Request	-	Special Use Permit of Major Public Utility - Water towers
Location	-	1910 Northover Road
Applicant	-	City of Toledo Dept. of Public Utilities 420 Madison Avenue, 4 th Floor Toledo, OH 43604
Owner	-	City of Toledo One Government Center Toledo, OH 43604

The staff recommends that the Toledo City Plan Commission recommend approval of SUP26-0002, a Special Use Permit for a major public utility – water towers at 1910 Northover Road, to Toledo City Council for the following **one (1)** reason:

SPECIAL USE PERMIT
TOLEDO CITY PLAN COMMISSION
REF: SUP26-0002
DATE: April 9, 2026
TIME: 2:00 P.M.

**DISTRIBUTION SYSTEM IMPROVEMENTS
ELEVATED STORAGE TANKS AND PUMPING STATIONS - PHASE 1**

SITE PLAN

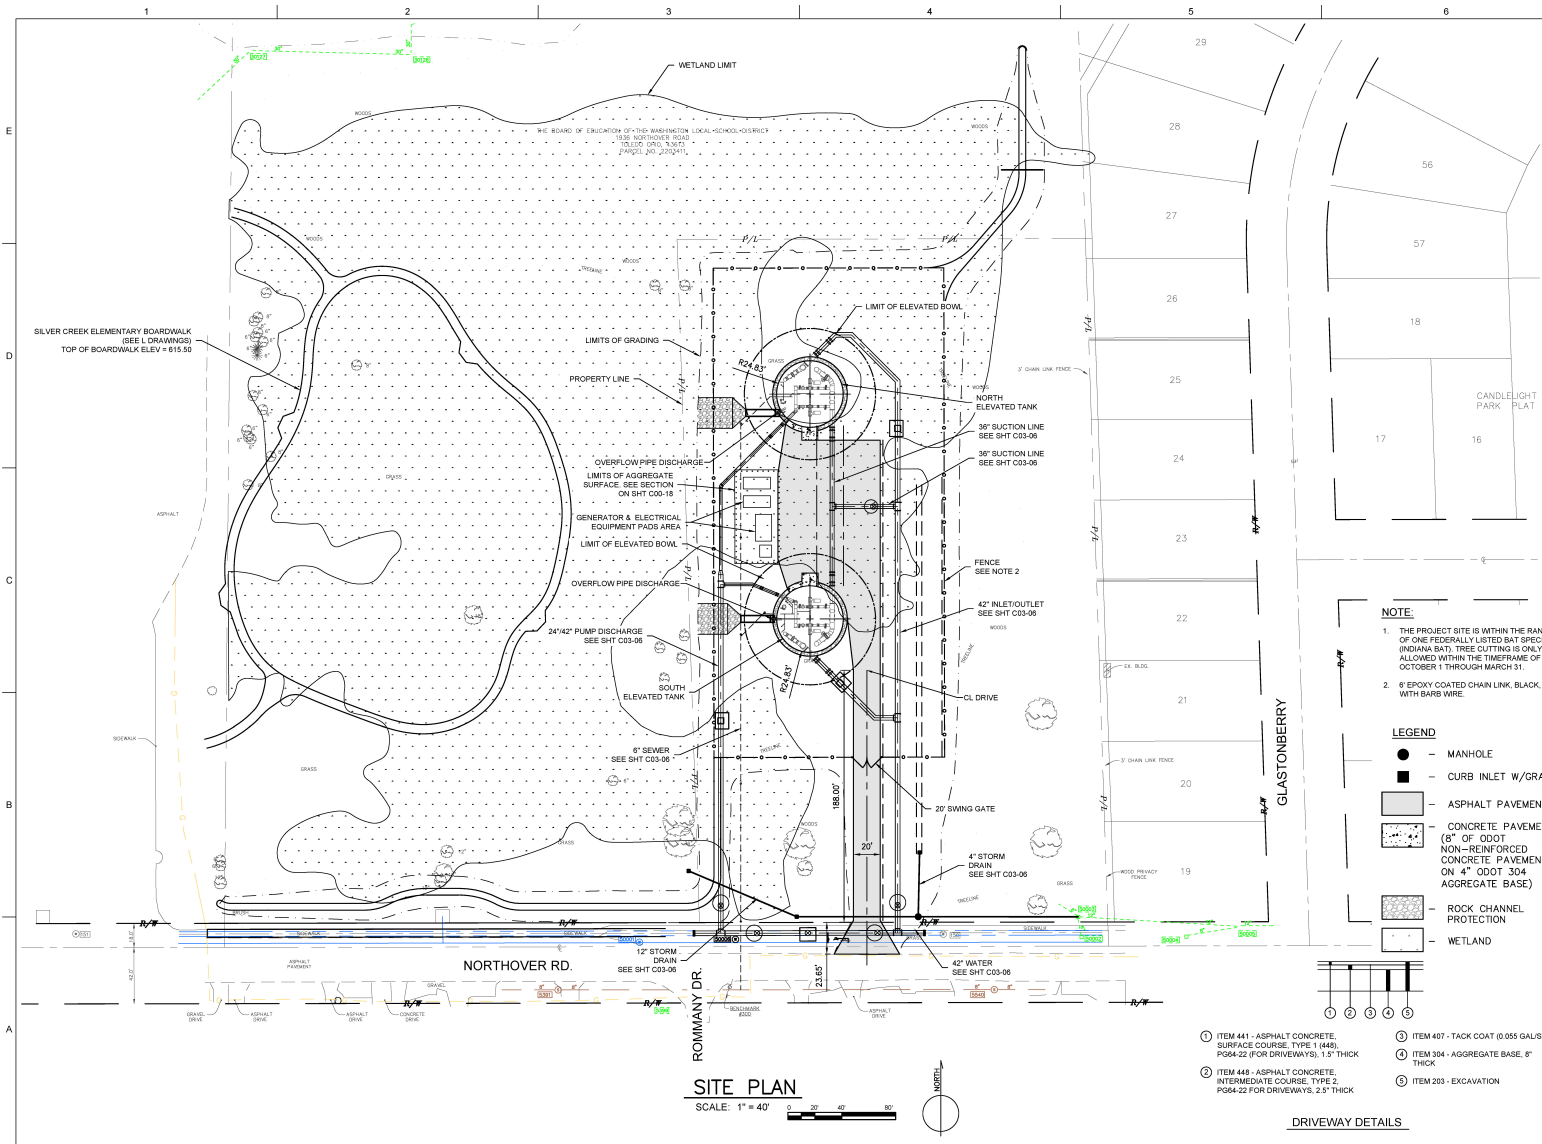
25. The use of barbed wire, razor wire, concertina wire or the like shall not be permitted in any zoning district except the Industrial districts and then only in the side and rear yards which not within 50 feet of a Residential district, not in the front yard setback and not anywhere along a street right-of-way. **Not acceptable as depicted. Six-foot (6’), epoxy coated chain link, black, with barb wire is not permitted within Residential Zoning Districts. Revised site plan showing fencing appropriate in Residential Zoning Districts is required.**

- e. The location, height and materials for any fencing to be installed and maintained. **Not acceptable as depicted. Fencing which is permitted in Residential Zoning is required.**

LANDSCAPE PLAN

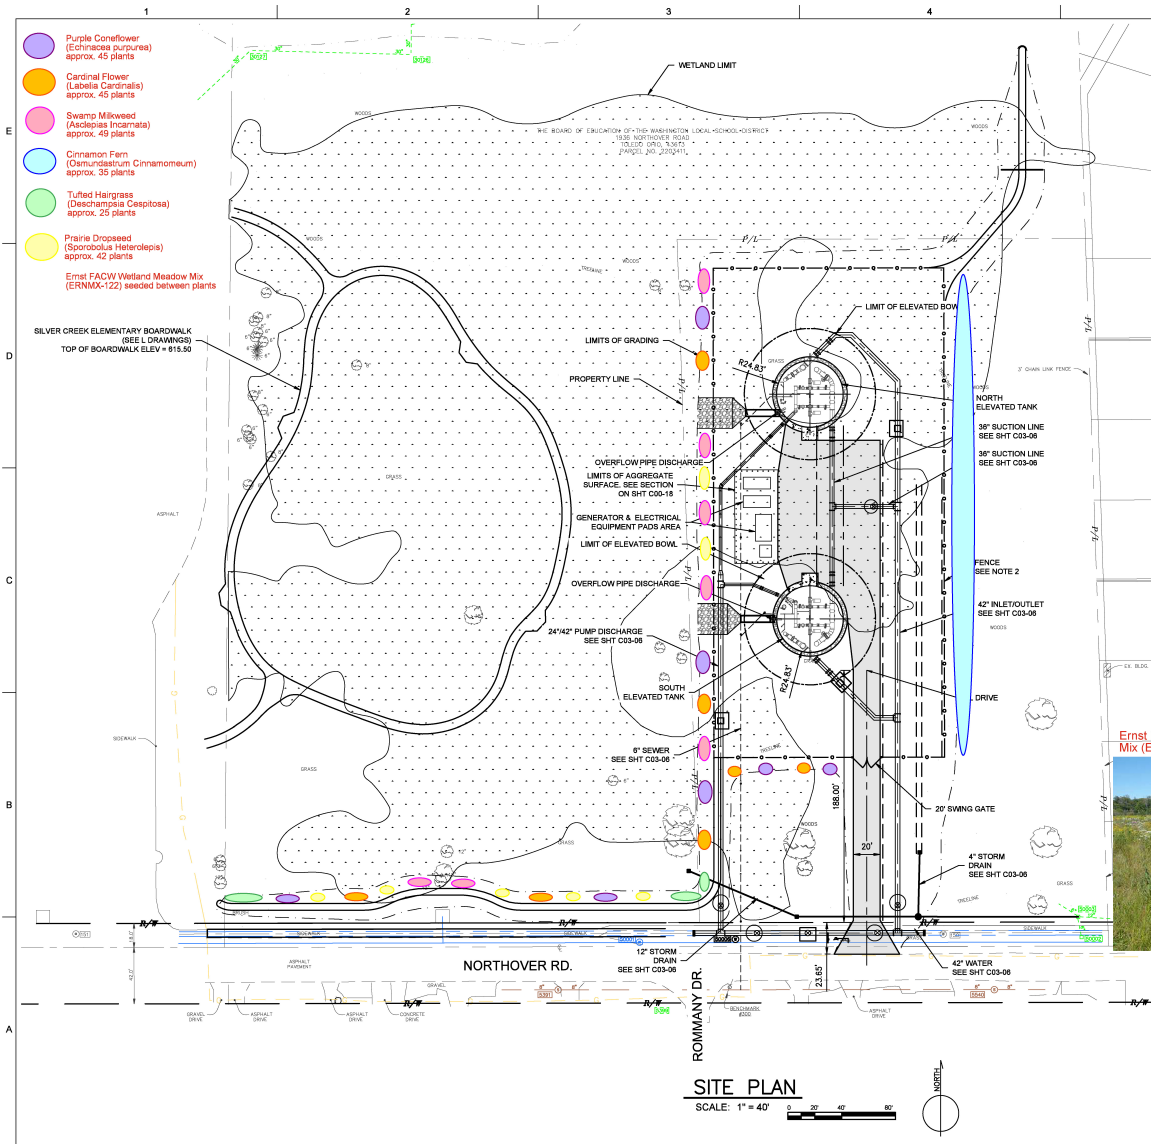
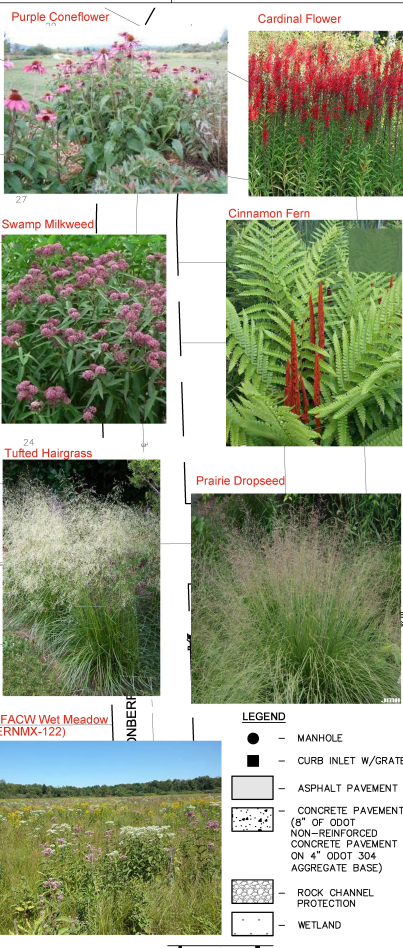
- a. A Type A Landscape buffer is required where Industrial Zoning Districts abut Residential Zoning Districts. A Type A Landscape buffer is required around the perimeter of the site to screen the base of the towers and equipment from abutting residential uses. **Acceptable as depicted.**
